Conversion kit Membrane (97502264 and 97502272)

Valid as from: September 2023

Fig. 1

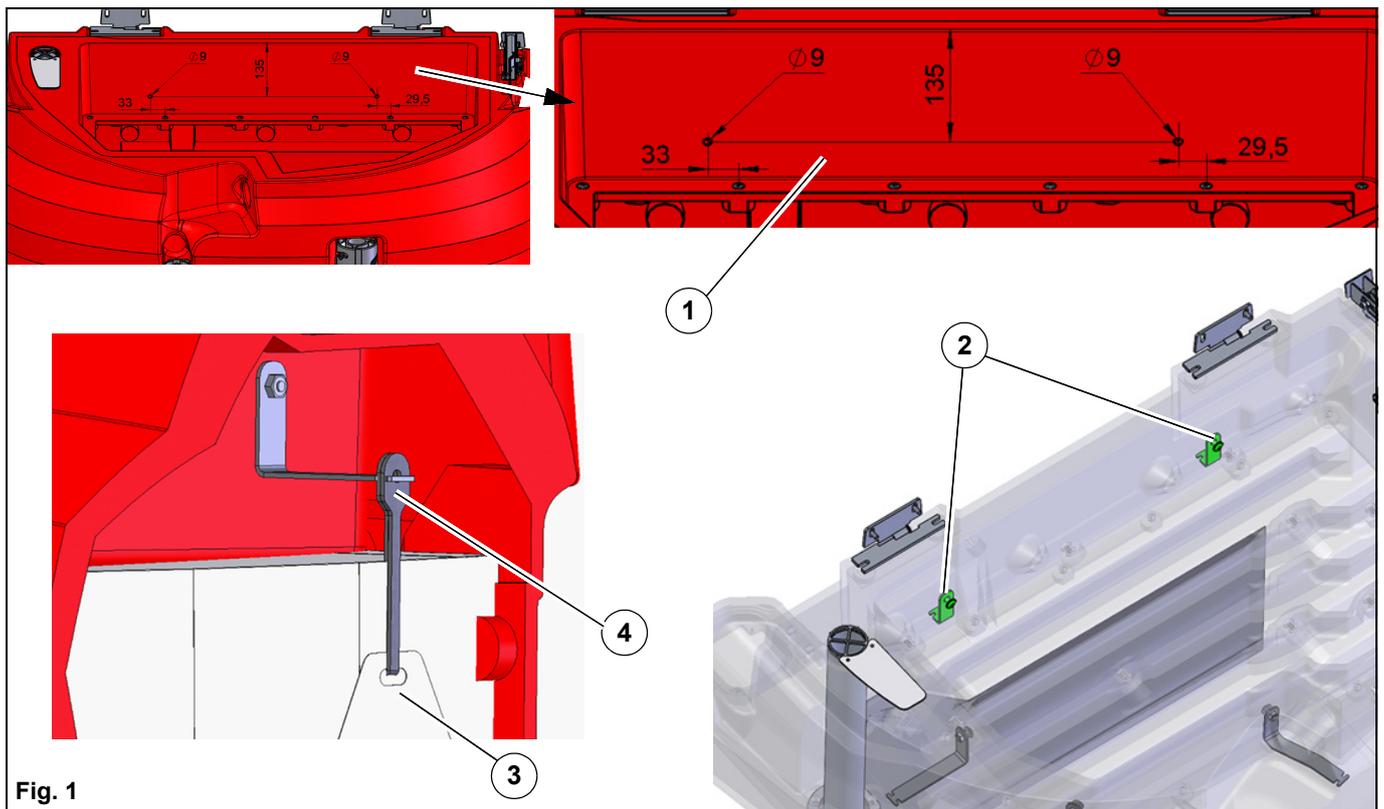
1. Remove existing membrane.
2. Drill two new $\varnothing 9$ holes in the inner wall of the tank according to the drilling diagram. **Fig. 1-1.**
3. Remove drilling chips.
4. Fasten the two holders to the tank with the M8x20 pan-head screws **Fig. 1-2.**
Tightening torque 7 Nm.
5. Hook the tabs **Fig. 1-3** of the new membrane into the 7 holders using the elastic bands **Fig. 1-4.**
6. Further installation of the membrane is done in reverse order to removal.
